DETERMINATION OF APPLICATION FOR MODIFICATION OF DEVELOPMENT CONSENT

Modification Application No: MA21/03333

Development Consent modified: DA20/0737

Address and particulars of title of land on which development to be carried out: 37 Gerrale Street Cronulla

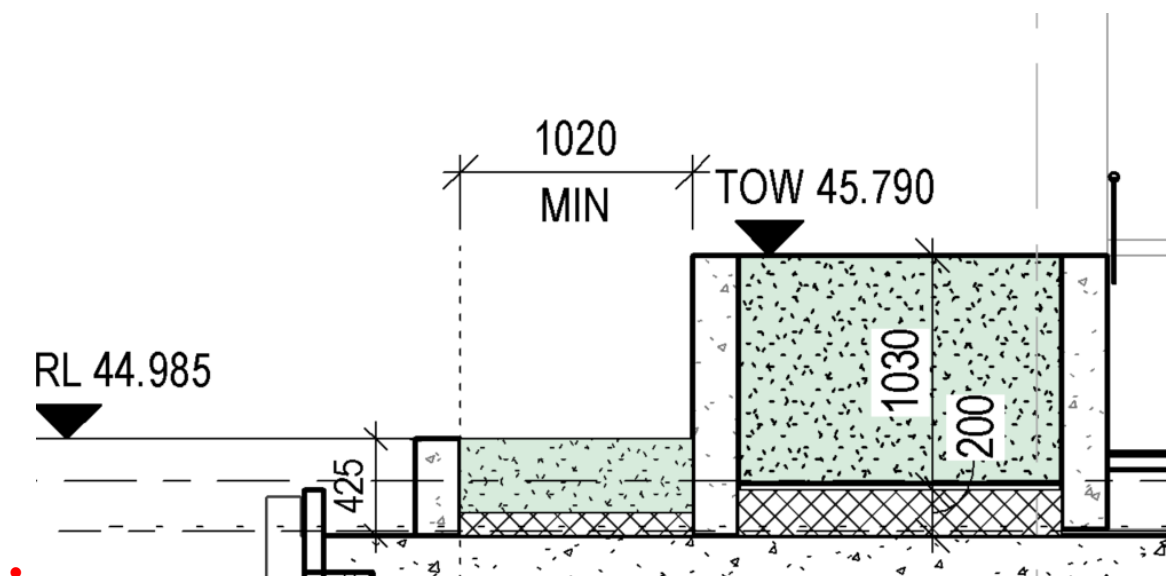
5. Amendment of Condition 16A by:

The replacement of iv) and v) with the following:

- iv) Any single garage accessing off a ~~6.2-5.8m~~ aisle must have a minimum width of 3m with a minimum door opening of ~~2.75~~3m wide x 2.2m high clear of any necessary hinges, jambs or fixtures required for the operation of garage doors or any services within the garage area.
- v) Any double garage accessing off a ~~6.25.8m~~ aisle must have a minimum width of ~~5.4-6m~~ with a minimum door opening of ~~5.15-5.4m~~ wide x 2.2m high clear of any necessary hinges, jambs or fixtures required for the operation of garage doors or any services within the garage area.
